SUBDIVISION REPORT - CONCEPT

▶ **FILE #:** 9-SB-24-C **AGENDA ITEM #:** 40
 POSTPONEMENT(S): 9/12/2024 **AGENDA DATE:** 10/3/2024

▶ **SUBDIVISION:** 0 BROOME RD

▶ **PROPOSED USE:** 28-lot townhouse subdivision

SHEET C-1

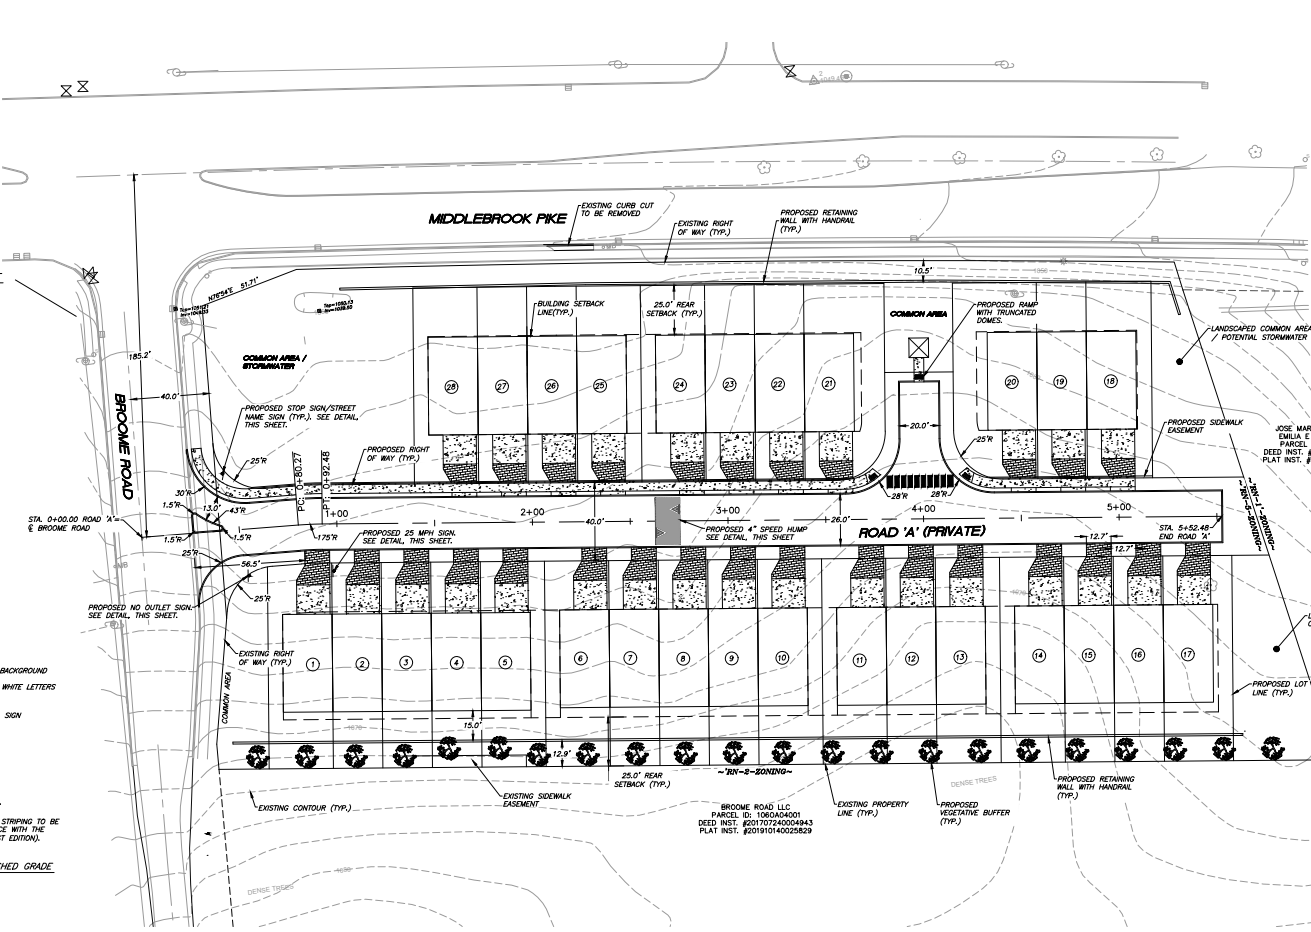
▶ **SUBDIVISION VARIANCES REQUIRED:** **VARIANCES:**
 1. Reduce the minimum intersection separation between the centerlines of Middlebrook Pike and Road 'A' from 300 ft to 185.2 ft (variance from Section 3.04.J.4).
 2. Reduce the minimum common area buffer strip depth required for double frontage lots between lots 18 - 28 and the Middlebrook Pike

1. Meeting all applicable requirements of the City of Knoxville Zoning Ordinance, including but not limited to, ensuring that the driveway of lot 1 meets the 50' corner clearance requirement, as shown on the plan.

6. Ensuring that the retaining wall along the northern boundary is identical or similar to the shared example, as shown in Exhibit B.
7. Installing a vegetative buffer along the southern boundary, as shown on the plan. During the design plan phase, a detailed landscape plan shall be provided for review and approval by Planning staff.

- 1) REDUCE THE REQUIRED BUFFER STRIP WIDTH FROM 25' TO 10' (APPLIES TO WOULD BE DOUBLE FRONTAGE LOTS)
- 2) INCREASE THE INTERSECTION GRADE FROM 1% TO 1.5%.
- 3) DECREASE THE REQUIRED INTERSECTION SPACING FROM 300' TO 185'.
- 4) DECREASE THE REQUIRED RIGHT OF WAY WIDTH FROM 50' TO 40' (PRIVATE ROAD)

- Approve the requested variance to reduce the minimum intersection separation between the centerlines of Middlebrook Pike and Road 'A' from 300 ft to 185.2 ft, based on the following evidence of hardship.

Approve the requested variance to reduce the minimum common area buffer strip depth required for double frontage lots between lots 18 - 28 and the Middlebrook Pike right-of-way from 25 ft to 10 ft, based on the following evidence of hardship.

Approve the concept plan subject to 7 conditions.

SHEET C-3

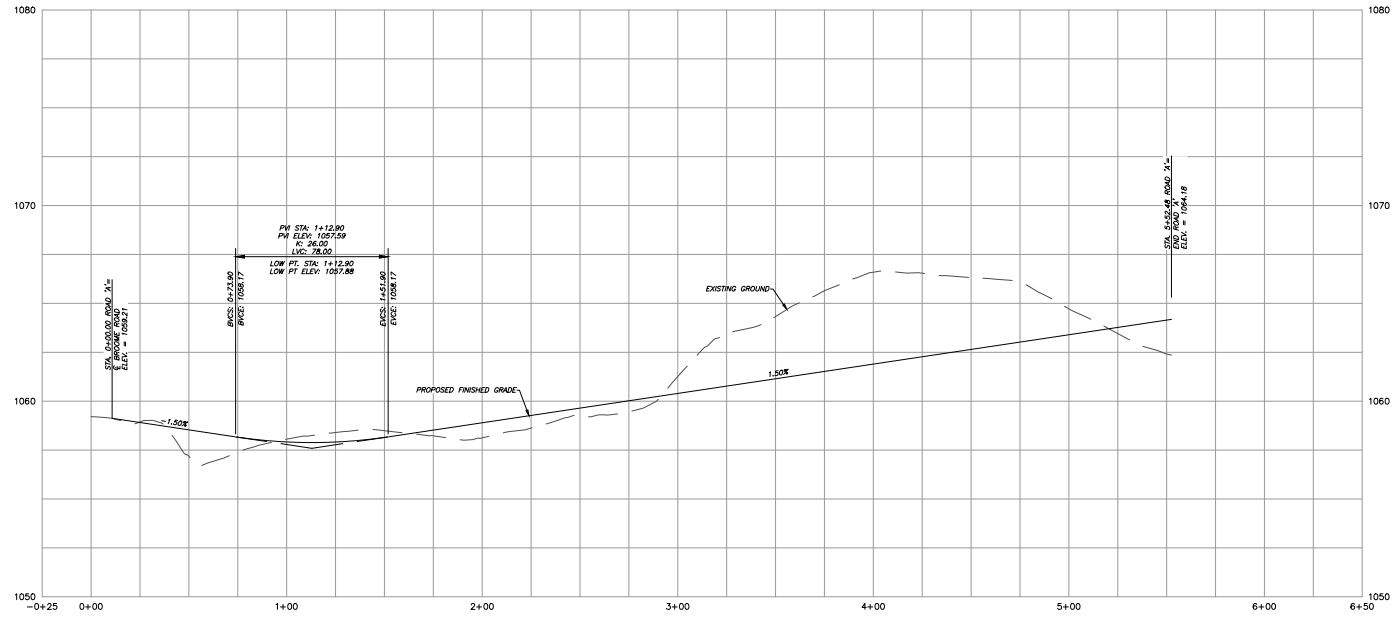
Increase the maximum intersection grade from 1% to 1.5%.

There are no safety nor functionality concerns with the request.
